1968 Corvette: Service News: Tune-up Specification Change

Subject: Tune-up Specification Change

Model and Year: 1968 Corvette with 427 cu. in. Engine, Manual Transmission and Air Conditioning

Date: February 1968, Volume 40, Issue #2

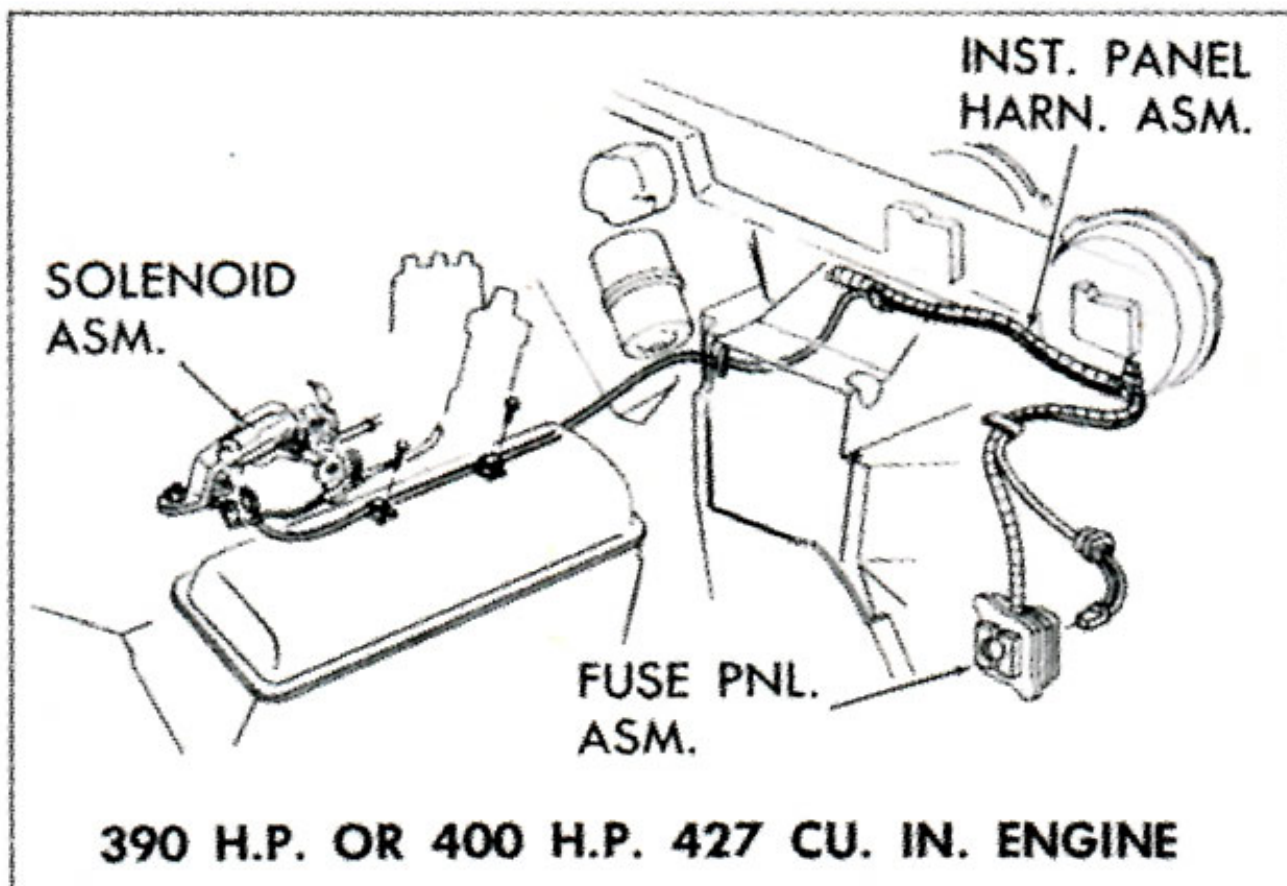
If the anti-dieseling solenoid on one of these vehicles requires replacement or adjustment, refer to the procedures given on Page 7 of this Service News issue. The 'Anti-Dieseling Solenoid Diagnosis Chart' on Page 7 of this issue should be of assistance in determining whether replacement is necessary. Figure 6 illustrates proper solenoid wire routing for either the 390 or 400 H.P. engine. The connector at the use panel should be inserted in the receptacle marked "IGN" for proper solenoid operation.

Fig. 7—Anti-Dieseling Solenoid Installation

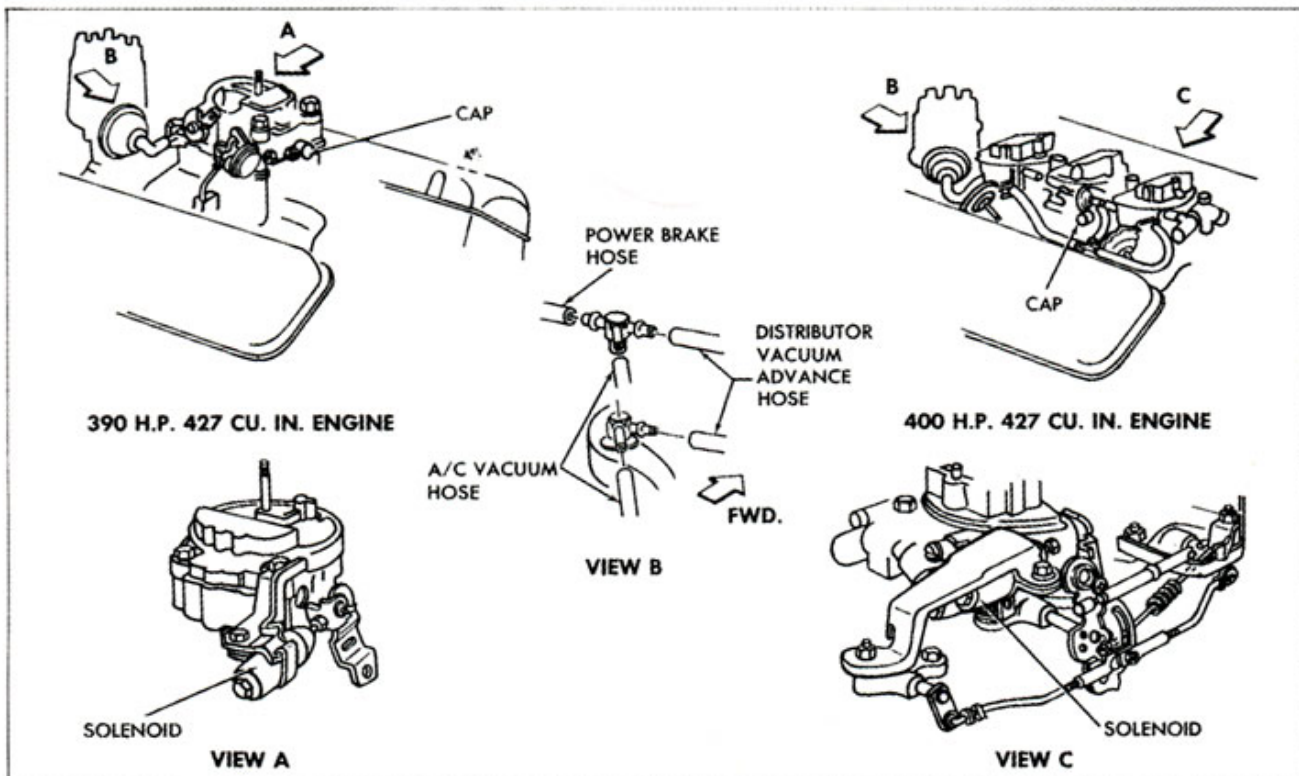
Figure 7 illustrates proper solenoid installation on both the 390 and 400 H.P. versions of the 427 cu. in. engine and also illustrates the correct intake manifold vacuum fittings for the full manifold vacuum distributor advance arrangement.
